Ordinary Meeting of Koata Hātepe | Regulatory Processes Committee Rārangi Take | Agenda

12:00pm Rātū Tuesday, 8 Here-turi-kōkā August 2023
Ngake (16.09)
Level 16, Tahiwī
113 The Terrace
Pōneke | Wellington

Business	Page No.
1. Meeting Conduct	7
1.1 Karakia	7
1.2 Apologies	7
1.3 Conflict of Interest Declarations	7
1.4 Confirmation of Minutes	7
1.5 Items not on the Agenda	7
1.6 Public Participation	8
2. General Business	9
2.1 Brooklyn Hill Permanent Improvements Oral Submissions	9
2.2 Let's Get Wellington MovingThorndon Quay Oral Submissions	197

Upper Brooklyn Road above Bidwill

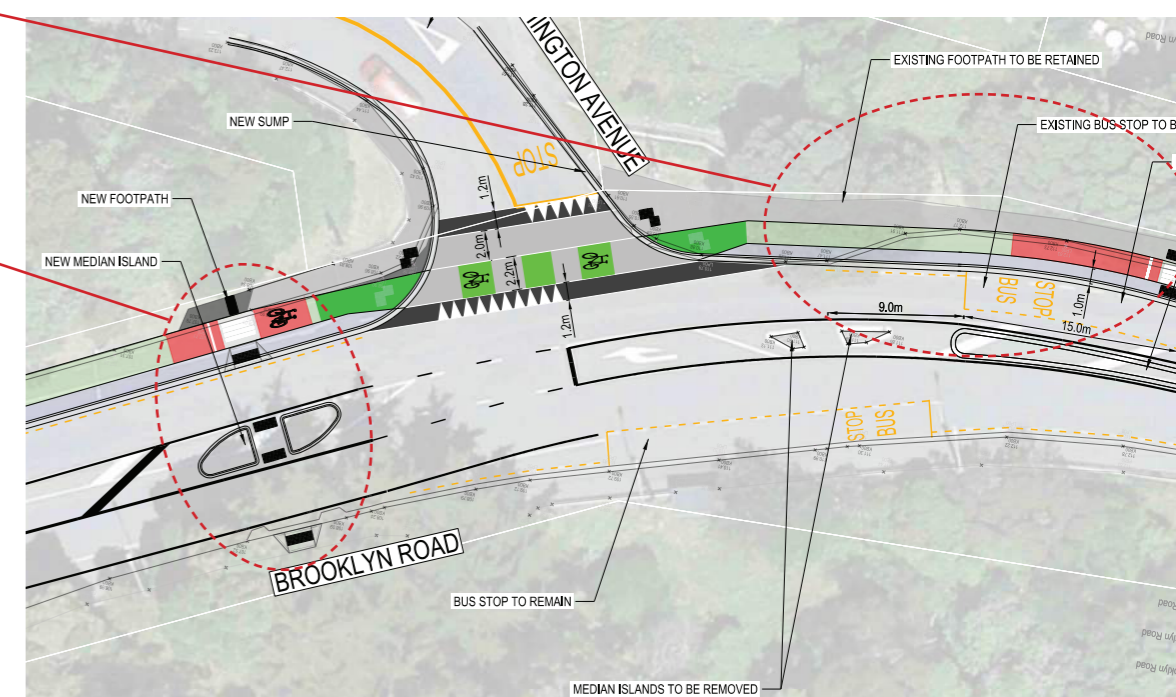
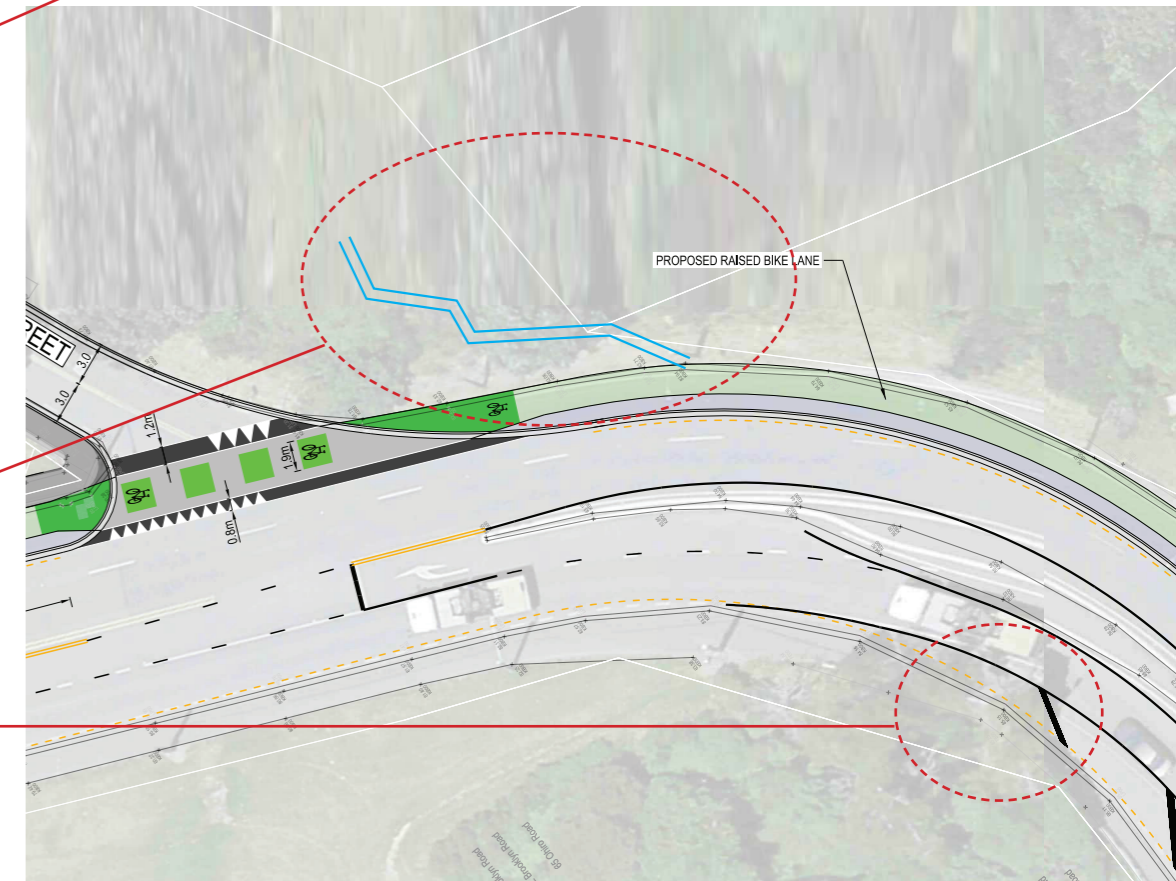
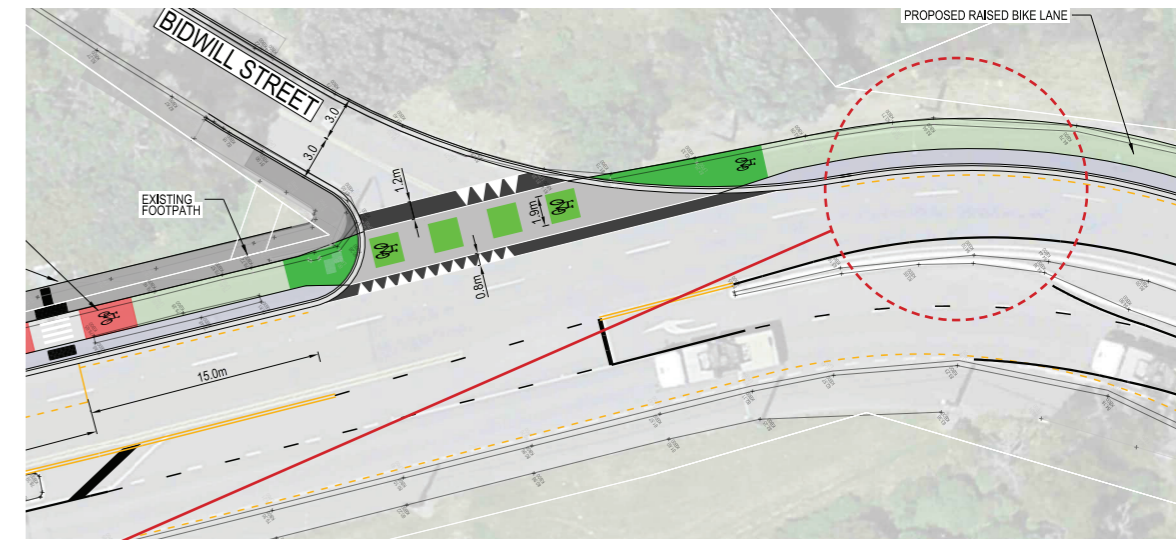
- The project should provide a walking route down the uphill side of Brooklyn Road between Washington and Bidwill. This is a great opportunity to provide a more direct route for those walking via Bidwill to Wellington High, Wellington College, Wellington East secondary schools, Massey University, and into Te Aro. Many of these students currently follow the 'desire line' using the median island at Rogers Corner and will be more inclined to do so when the authorized refuge crossing is moved further down Brooklyn Road. I understand this pedestrian route was considered as an option and rejected due to the cost. However the current drawings show a 1.5m wide zone between the cycle and vehicle lanes which could function as a narrow footpath for those keen to use this side of Brooklyn Road. As cyclists are moving uphill there is less risk of pedestrians and bikes colliding. Also, if this strip was moved to the bank side it would help distance the bikes from dirt and rocks that spill off the bank and give pedestrians more distance from moving vehicles.

- In addition to recognizing that pedestrians will walk on the uphill lane side regardless of what's built, a set of timber steps between Rogers Corner and Bell Road would provide a direct route that would avoid pedestrians having to lose height by dropping to the Brooklyn/Bidwill intersection and then back up to the Bidwill/Bell Road intersection. This would avoid the tight steep bank on the downhill/south side of Bidwill where it meets Brooklyn Road. This should also be reviewed alongside what Wellington Water's long-term plans are for the Bell Road Reservoir as one option was for a direct vehicle connection at Rogers Corners to avoid the tight Bell Road route for trucks. Anticipating that may help make the steps solution more viable.

Ohiro Road - Brooklyn Road to Todman

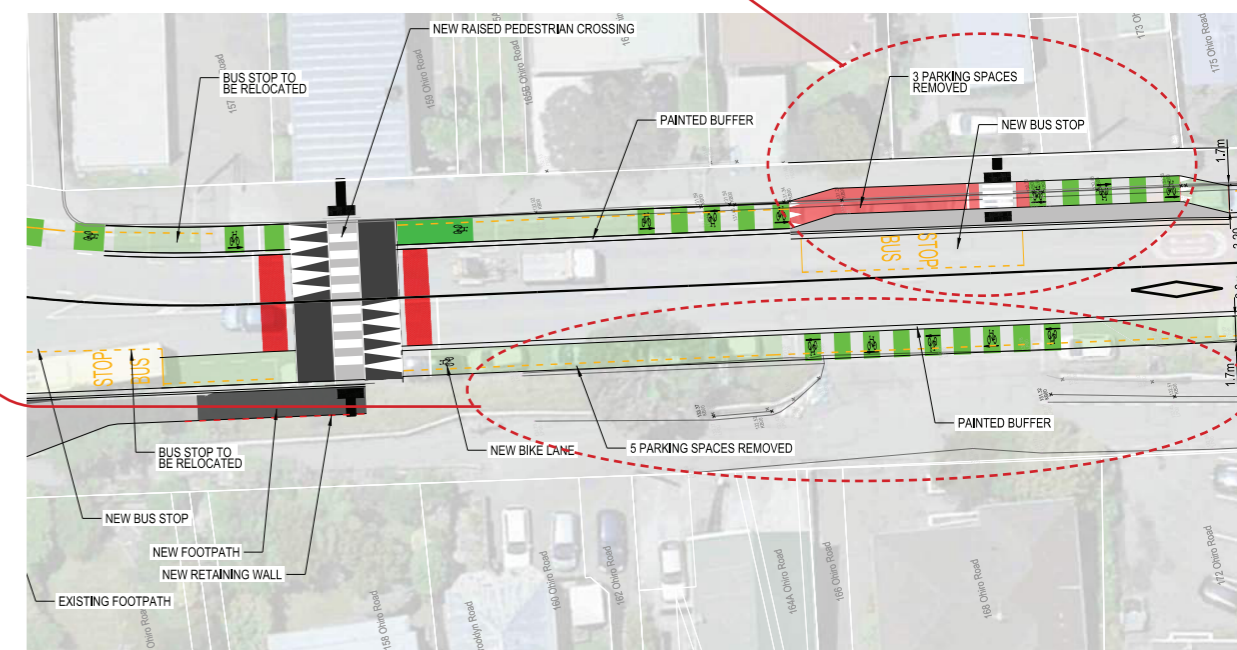
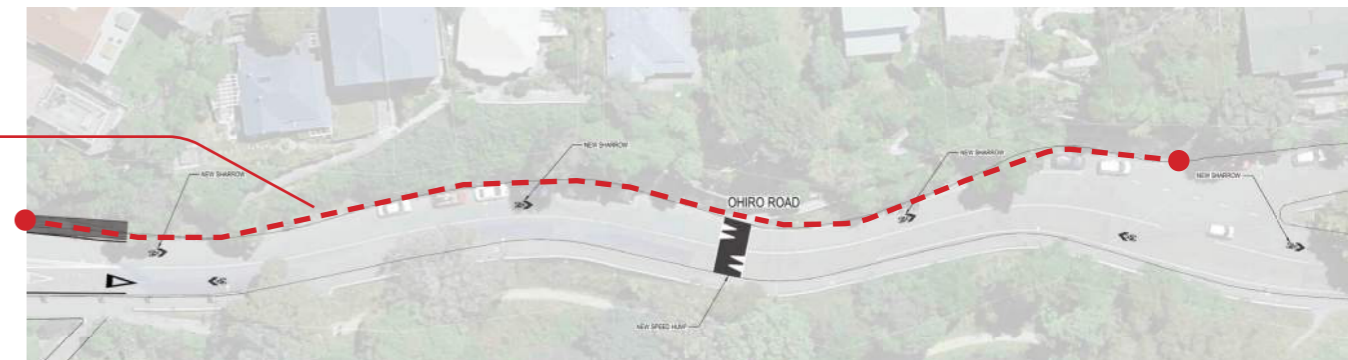
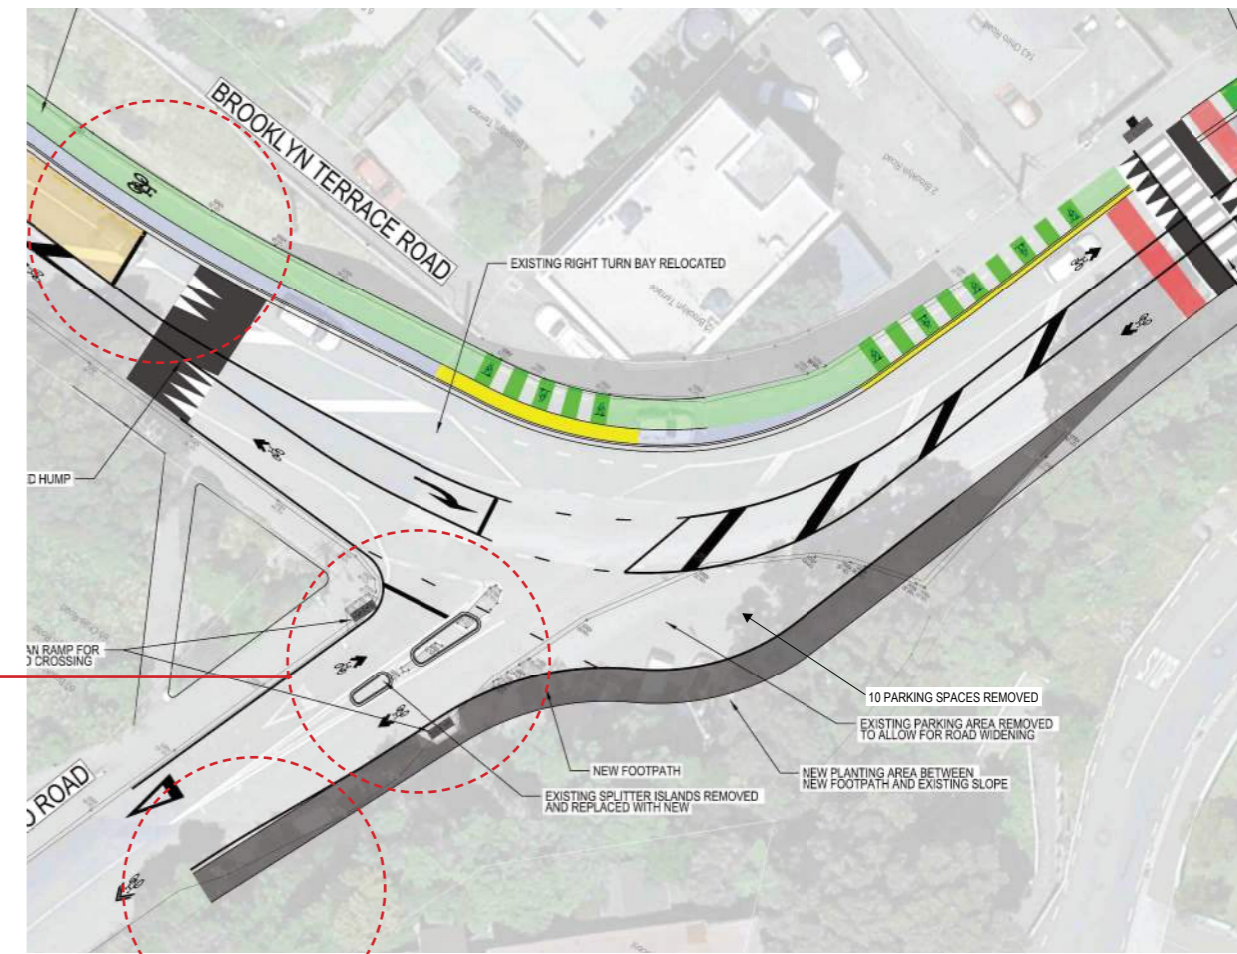
13. The proposal to make improvements to the Brooklyn/Ohiro intersection for the safety of all users, but particularly the most vulnerable who are walking and cycling is great! I do think the crossing just below the intersection of Brooklyn and Ohiro not being a proper pedestrian crossing is a shame as that will be the only uncontrolled main crossing on the route between Brooklyn and the CBD... however I do understand the explanation that vehicles turning right down into Ohiro Road won't have a safe opportunity to align giving way to both the downhill traffic and pedestrians on a zebra crossing who have the right of way. I realize this will come in the Detailed Design phase but the current concept drawings do not give the impression of slowing down the Ohiro Road traffic enough. From my observations many drivers do not indicate or feel they need to slow down and hence for pedestrians crossing Ohiro Road here there is a decent amount of goodwill and luck in deciding to step out.

14. As a resident of 132 Ohiro Road, one of 5 properties whose access is the first path down Ohiro Road, I would like to see the carparks between the pedestrian ramp and our path retained, even if that means a very narrow footpath linking to our shared path. There will be a reduced number of on-street carparks but it will retain the ability to drop off and pick up nearer our path, particularly as the layby above is proposed to be removed to make space for a safer intersection layout.

Cleveland Street

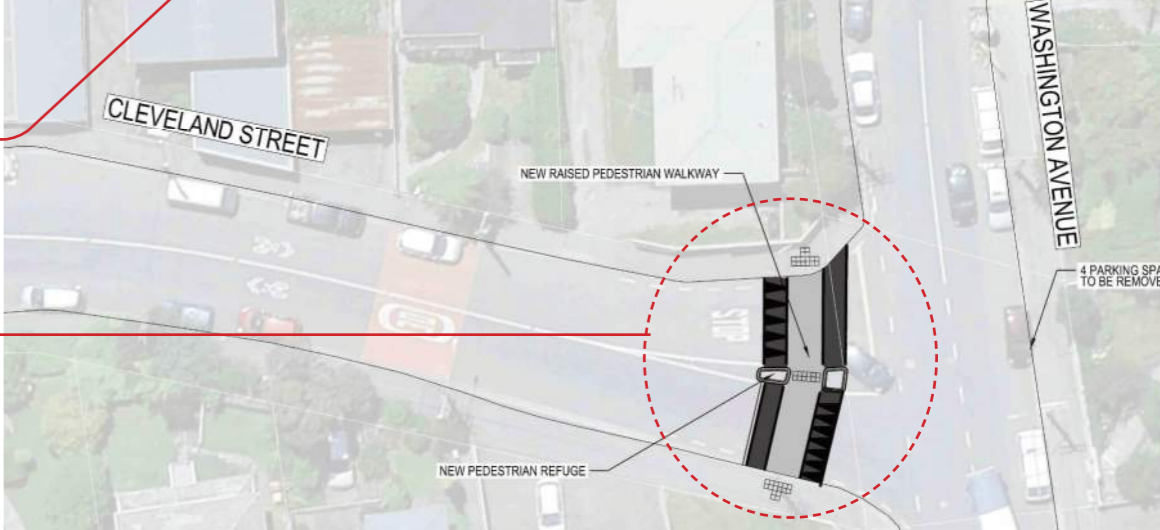
- 18. I support the introduction of a raised crossing to upgrade the current on grade zebra crossing near the intersection with Jefferson Street. For several years I managed the parent volunteers who monitor and support students walking and cycling to school. The improvements here will make those parent's job safer and help some parents be more willing to let their children walk or bike to school.
- 19. I support the raised pedestrian walkway across Cleveland at the Washington Ave intersection.

Ohio Road below Brooklyn Road

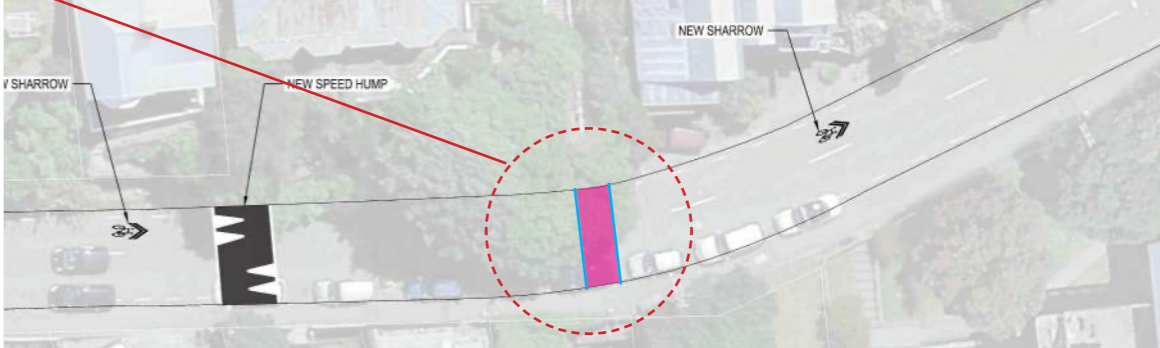
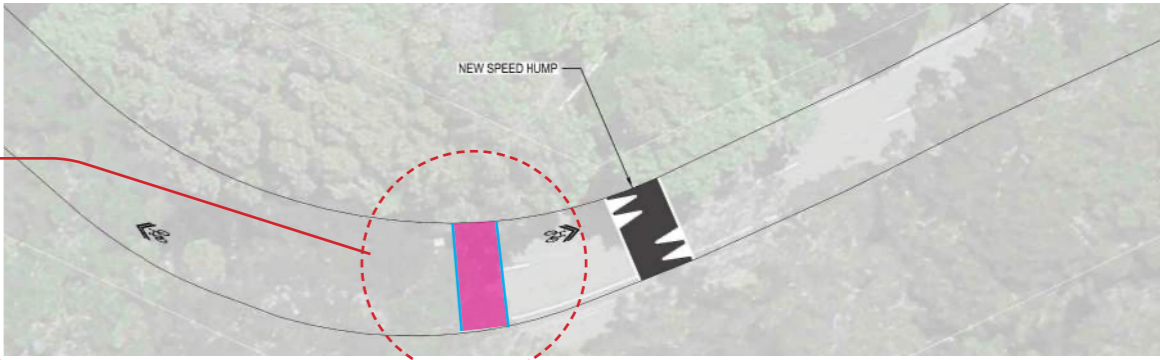
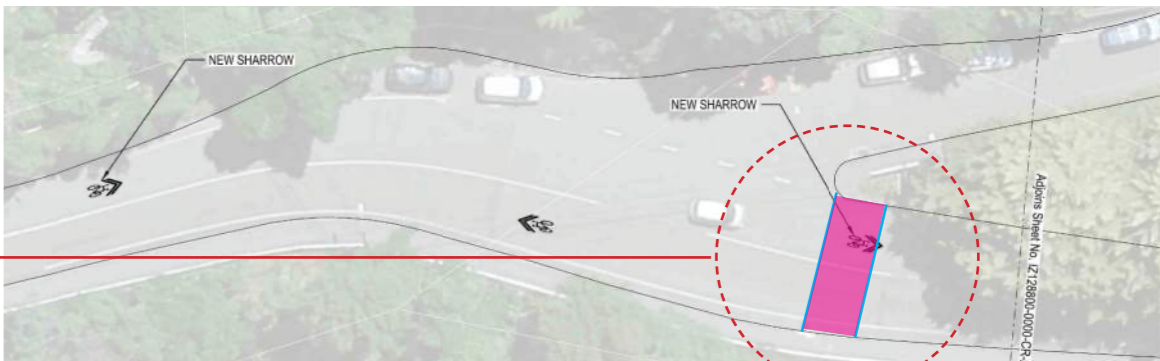
- 20. While I have no problem with the addition of speed humps down Ohio Road I do not anticipate that I would then choose this route over heading down Brooklyn Road as I do now. Brooklyn Road is wider, has better visibility, is less prone to being wet as its more open, and is not as steep. Hence it's easier to control your speed as a cyclist and there is more time and space to anticipate what vehicles are doing vs the narrow tight corners on Ohio Road.

- 21. I suggest the first speed hump is replicated or moved down to provide a safer pedestrian route across Ohio to Tanera Cres and down to Tanera Park. This is a well-used route for pedestrians walking to the CBD via Tanera Park and Aro St but also for weekend sport at the old Bowling Club and Tanera Park. All the sport here is for primary school aged children so promoting and enabling them and their families to walk to their games and practices would be a great benefit. Even more so if it enables the children to begin to do so independently.

Parking adjacent to the State Highway 1 overpass

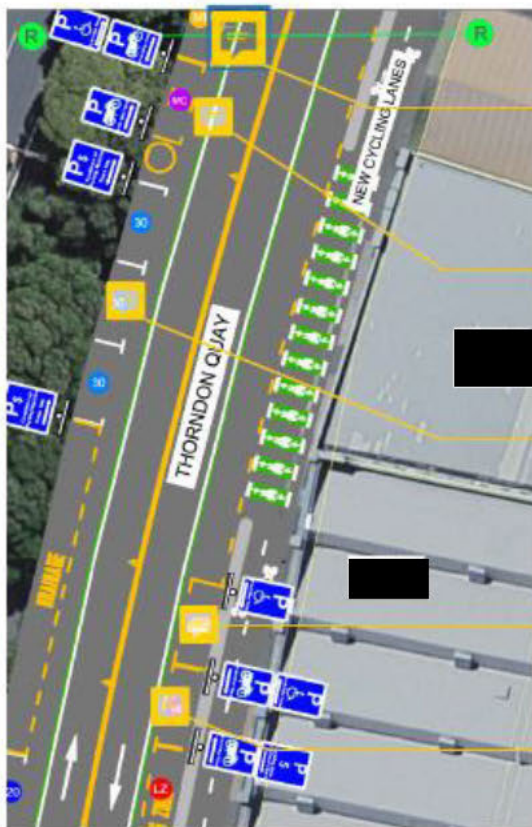
The proposed loading zone is in a location where there are no businesses that require goods delivery. As this loading zone is unlikely to be used for its intended purpose we propose converting this to car parking.

Figure 1: Thorndon Quay, between Tinakori Road and Mulgrave Street

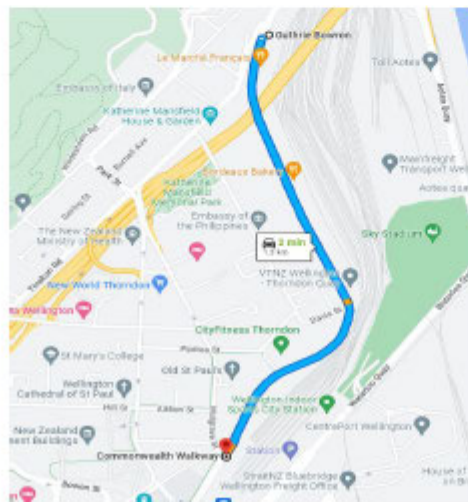
- 3.4 The consultation document refers to the speed limit being reduced from 50 km/h to 30 km/h between Tinakori Road and Mulgrave Street (refer Figure 1 below). This is being proposed on the basis that *"This reflects the new street environment, increased number of cyclists, and suitability for the large number of children using the street."*

- Given the nature of the businesses along this route we are somewhat surprised by LGWM's view that it needs to be suitable for the *"large number of children using the street."* Can LGWM provide its rationale and modelling that shows the number of children predicted to use the route?

- Traditionally this route has been used by commuters driving into and out of the city with according to Wellington City Council information an average monthly traffic count of 295,000. Presumably these changes will change the behaviours of those commuters in cars, for example they may change modes or use another route. Can LGWM share the impact analysis in this regard?

Figure 2: Excerpt from Plan 7, Designing for safe truck access

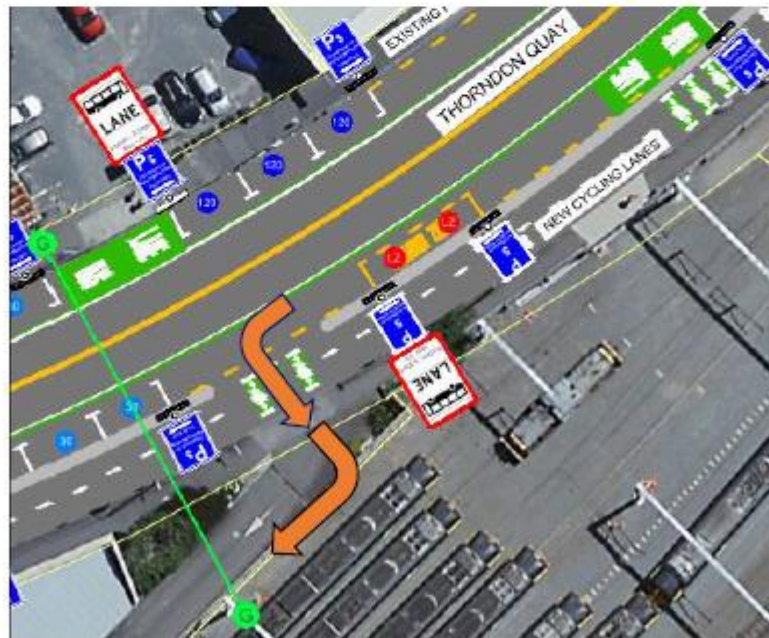
- 3.6 The proposal includes installing a raised safety buffer between the cycleway and traffic lanes. Understandably, given the stage of this consultation there is insufficient detail provided regarding the design of the raised safety buffer. Notwithstanding, we request LGWM consider the following:

- Trucks will deliver large loads and the safest place for unloading these trucks is to continue to allow direct access to these buildings. Trucks will also need to access properties for regular service and maintenance.

- Figure 2 above is an excerpt from Plan 7 of the Supporting Drawings provided by LGWM. We have inserted two orange arrows to indicate the potential hypothetical path a truck would take to access the side road. In our view the position of the raised safety buffer and the location of the Loading Zone are sub-optimally designed for this manoeuvre to be safely completed.

Improve protection against illegal stopping at automotive businesses including [REDACTED]

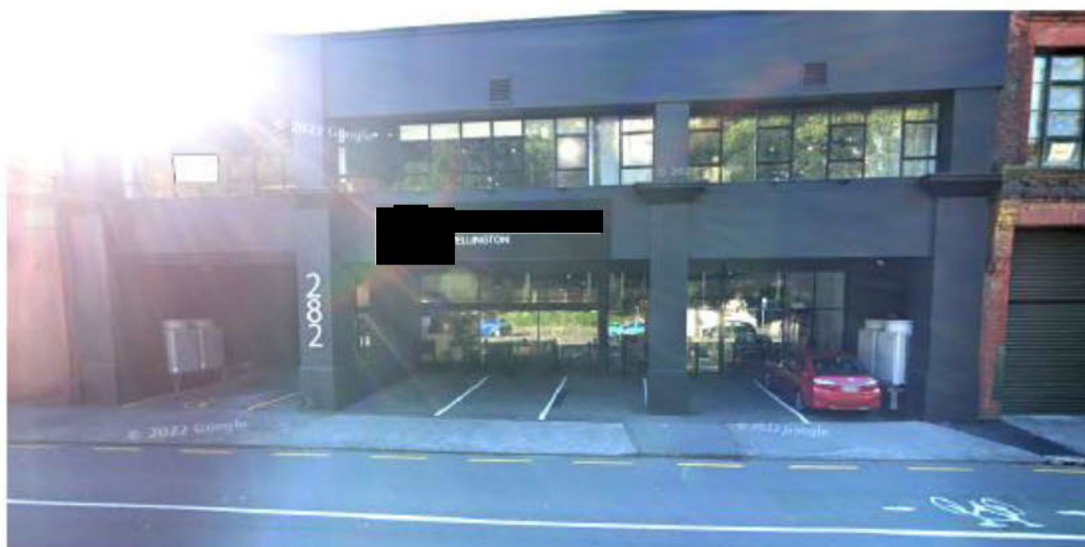
Clearance for sightlines at [REDACTED] is the perfect size to squeeze another car parked on the end, blocking visibility. This is one of a few examples in the plan, but vehicle-related businesses such as [REDACTED] and [REDACTED] are possibly the most likely to suffer illegal stopping 'just for a few minutes'. This needs preventative measures that do not rely on enforcement.

Opportunity to improve setbacks at [redacted] fuel station

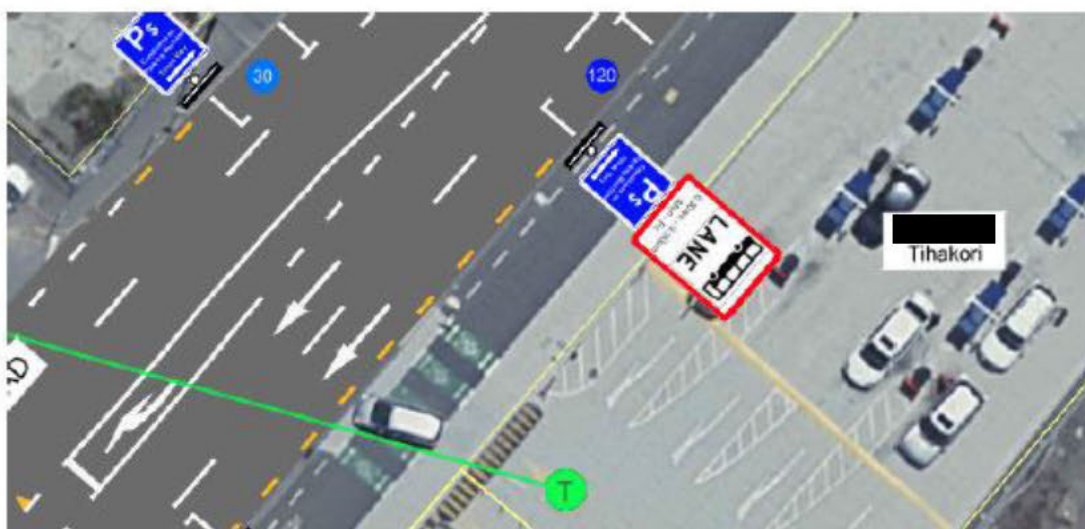
Vehicles queuing to leave the [redacted] fuel station (plan 21) routinely block the cycleway (see extract from plan 21 below). Please take the opportunity to increase the parking setback, improving sightlines for drivers and reducing the likelihood of these drivers blocking the cycleway.
